RIO DE FLAG FLOOD CONTROL PROJECT VALUE ENGINEERING STUDY

March 16, 2010, Flagstaff, Arizona

Priority Alternative Cost Summary

ALTERNATIVE 2A **SHORTEN CONFLUENCE WITH UNDERGROUND JUNCTION BOX** **RDF STATION 48+30 TO STATION 54+65** **BEAVER AND EXISTING RDF PARK**

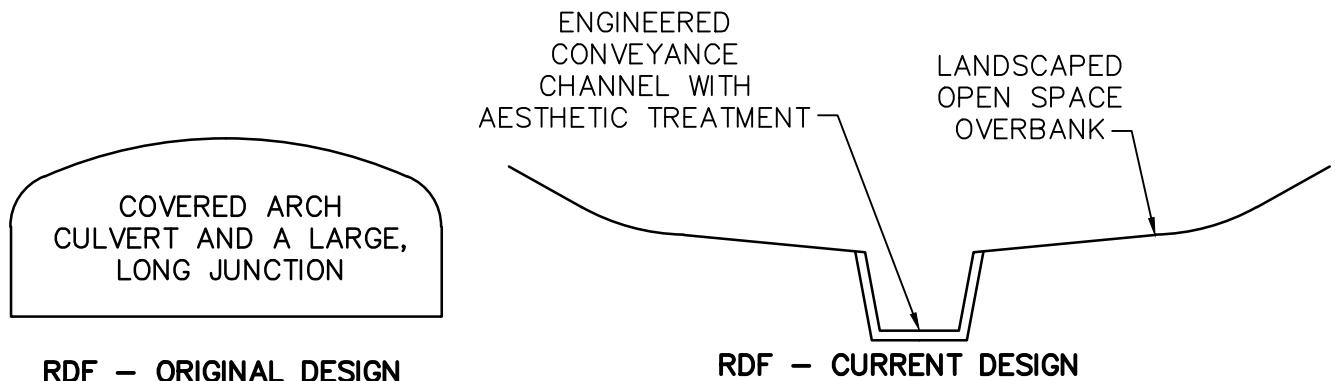
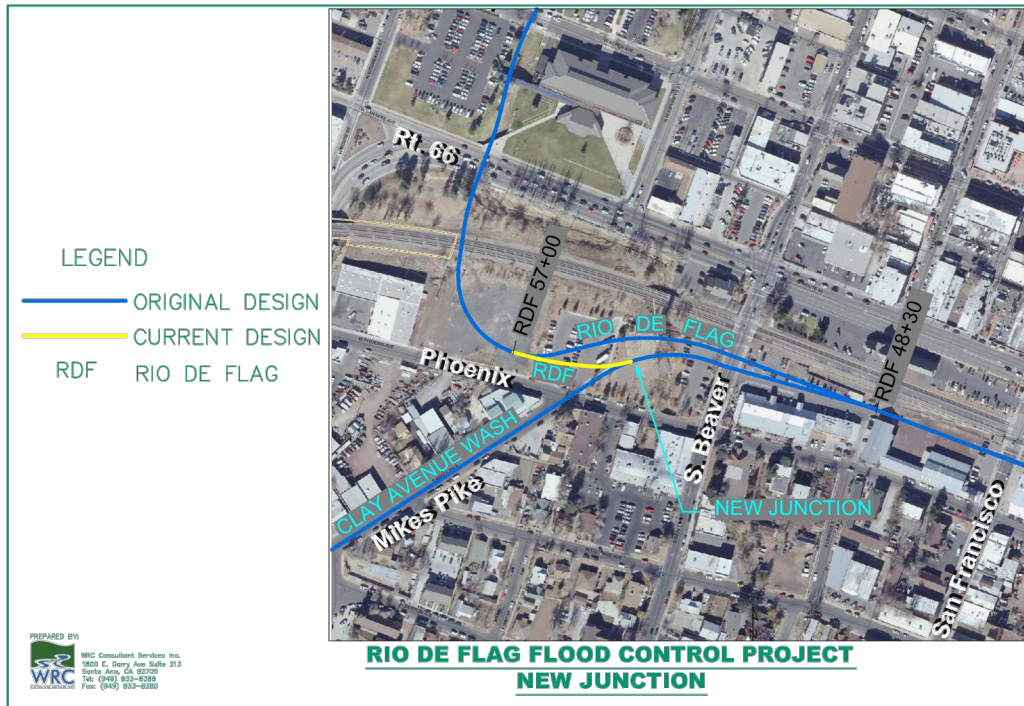
RDF – ORIGINAL DESIGN
870± LF
DISTANCE FROM RDF STATION
57+00 TO RDF STATION 48+30 THE
ORIGINAL JUNCTION

RDF – CURRENT DESIGN
235± LF
DISTANCE FROM RDF STATION
57+00 TO RDF STATION 54+65 THE
NEW JUNCTION

ORIGINAL DESIGN COST	\$3.5 million + \$500,000* + COST FOR RDF 52+70 TO 54+65 28' WIDE ARCH CULVERT
CURRENT DESIGN COST	\$2.5 million + COST FOR RDF 52+70 TO 54+65 24' WIDE ARCH CULVERT
SAVING	>\$1.5 million
* CAW 1+50 TO 3+00± (PHOENIX AVE) U/S EX. CONFLUENCE WILL BE ELIMINATED WITH NEW CONFLUENCE ADJUSTMENT

SHORTEN CONFLUENCE WITH OPEN CHANNEL AREA RDF STATION 48+30 TO STATION 54+65 BEAVER AND EXISTING RDF PARK

ORIGINAL DESIGN COST	\$3.5 million + \$500,000* + COST FOR RDF 52+70 TO 54+65 28' WIDE ARCH CULVERT
CURRENT DESIGN COST	\$2.0 million + COST FOR RDF 52+70 TO 54+65 24' WIDE ARCH CULVERT
SAVING	>\$2.0 million

ALTERNATIVE 3

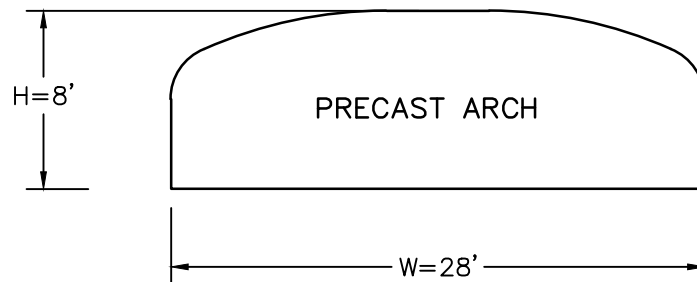
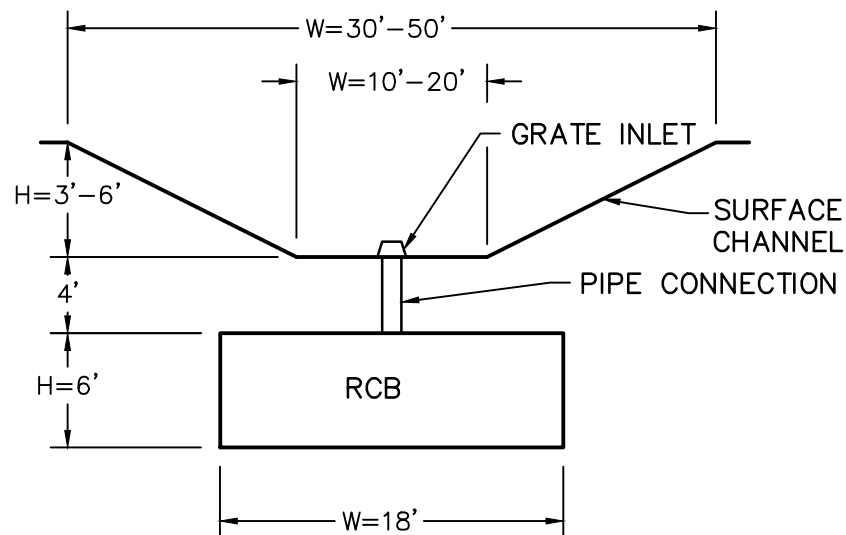
REPLACE ARCH CULVERT WITH COMPOSITE RCB
AND GRASSLINED OR TURF MAT LINED OPEN CHANNEL
RDF STATION 62+00 TO STATION 86+17 – ROUTE 66 TO BONITO

ALTERNATE TURF MAT OPEN CHANNEL ON TOP OF RCB

ALTERNATIVE 4A

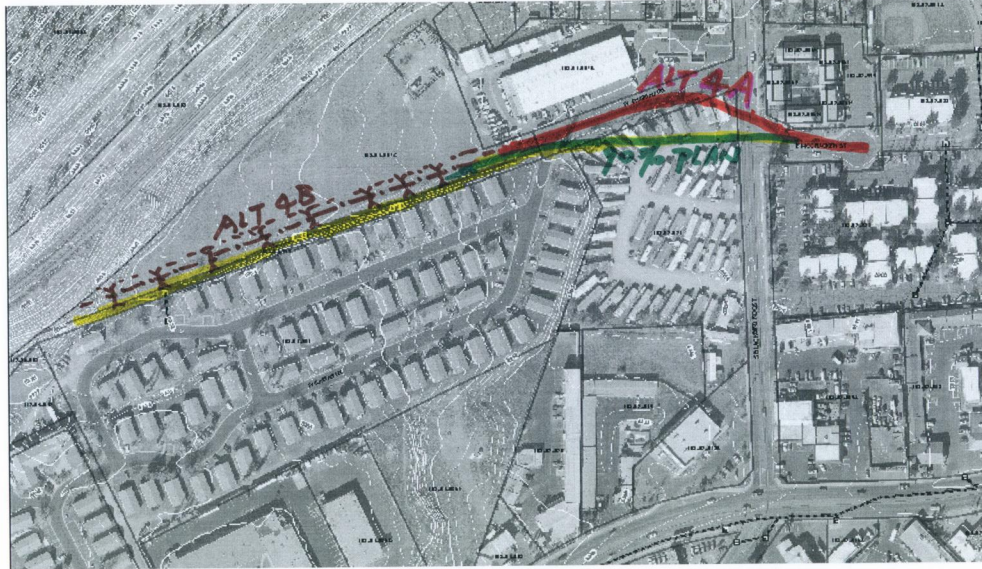
REALIGN THE CAW ARCH CULVERT AND REDUCE IMPACTS ON TRAILER PARK
CAW STATION 32+00 TO STATION 36+95
U/S BLACKBIRD ROOST TO TRAILER PARK

ARCH CULVERT THROUGH TRAILER PARK TAKING ABOUT 7 TRAILERS

ARCH CULVERT THROUGH NORTH SIDE OF TRAILER PARK ALONG W. CHATEAU DRIVE UNTIL THE CORNER OF W. CHATEAU AND S. BLACKBIRD ROOST. CUT THE CORNER TO JOIN E. McCRAKEN ST. ALIGNMENT. THIS WILL TAKE ABOUT 3 TRAILERS AND INCREASE THE CULVERT FROM 400 LINEAR FEET TO 480 LINEAR FEET

ALTERNATIVE 4B

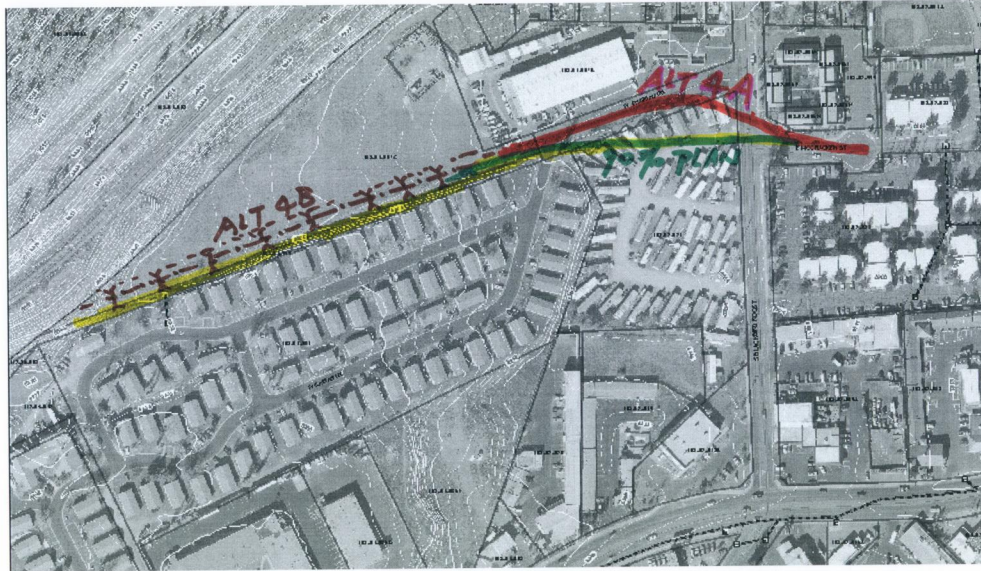
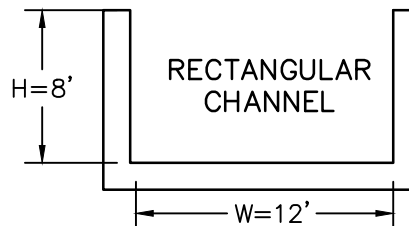
WIDEN CHANNEL – REPLACE RC CHANNEL WITH UNLINED OPEN EARTHEN CHANNEL
CAW STATION 36+95 TO STATION 48+55
U/S TRAILER PARK

ALTERNATIVE 5

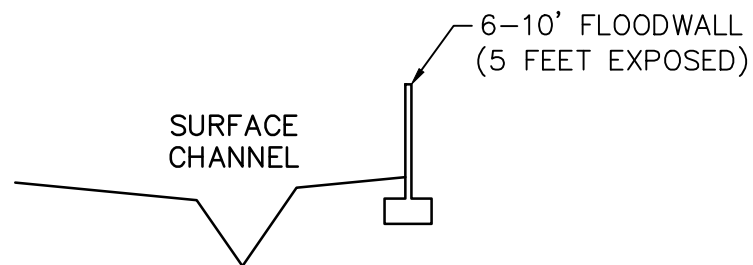
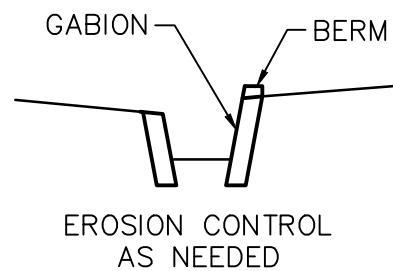
CHANNEL IMPROVEMENTS WITH A BERM(S).

ELIMINATE FLOODWALL

RDF STATION 97+50 TO STATION 112+00 – THORPE TO BEAL

ALTERNATIVE 6

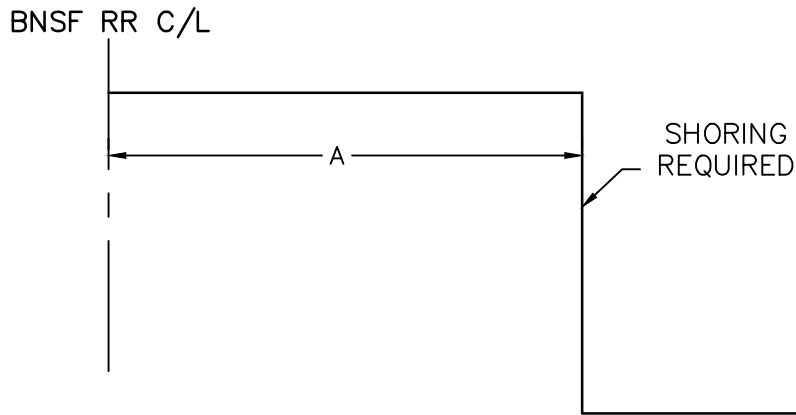
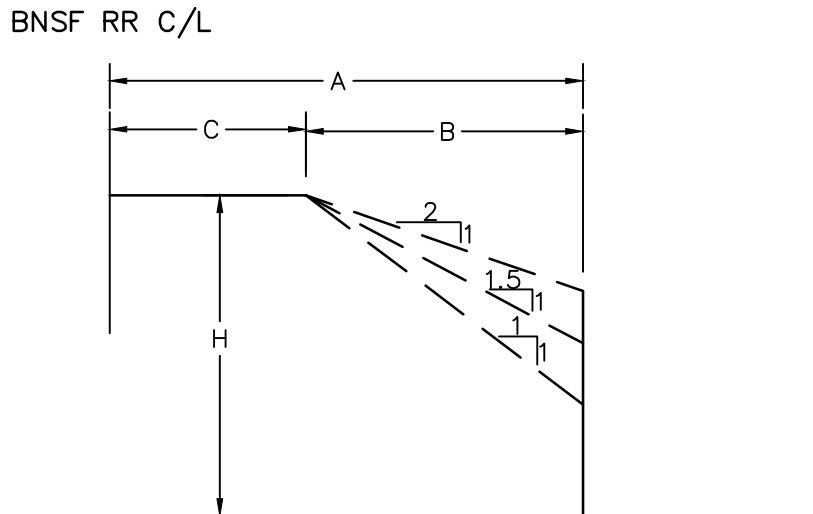
NEGOTIATE A LARGER CONSTRUCTION EASEMENT TO REDUCE SHORING
RDF STATION 40+15 TO STATION 54+10
ALONG BNSF RR TRACKS

ALTERNATIVE 7

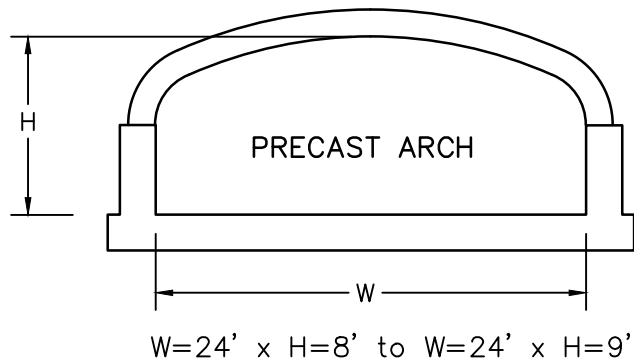
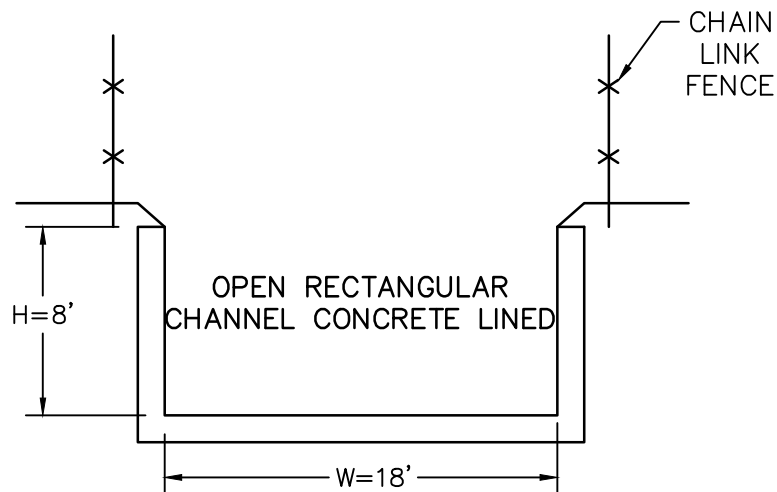
REPLACE ARCH CULVERT WITH RC CHANNEL
CAW STATION 18+00 TO 28+00
FIVE-POINT INTERSECTION TO McCRAKEN

NOTE: FIRE STATION PROPERTY RESALE VALUE MAY BE REDUCED W/ OPEN CHANNEL

ALTERNATIVE 9

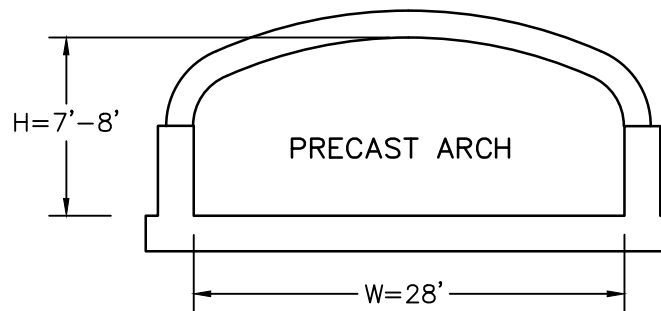
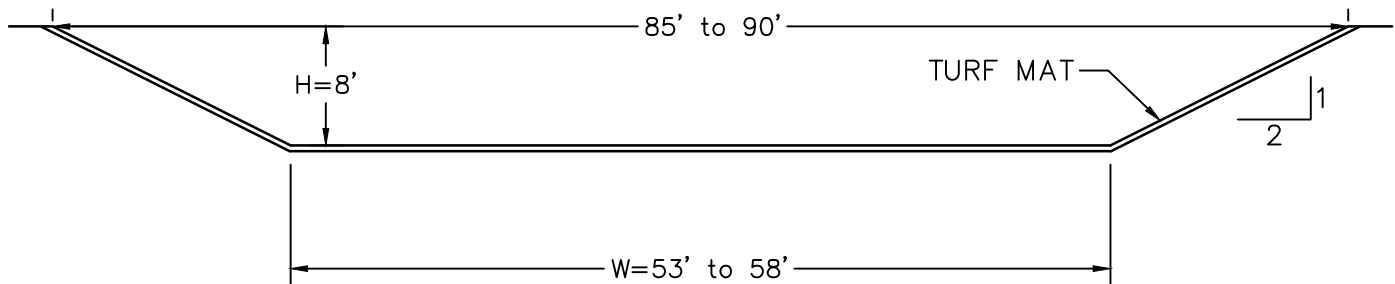
REPLACE ARCH CULVERT WITH OPEN CHANNEL
RDF STATION 62+50 STATION 70+00
SANTA FE/ROUTE 66 TO BIRCH
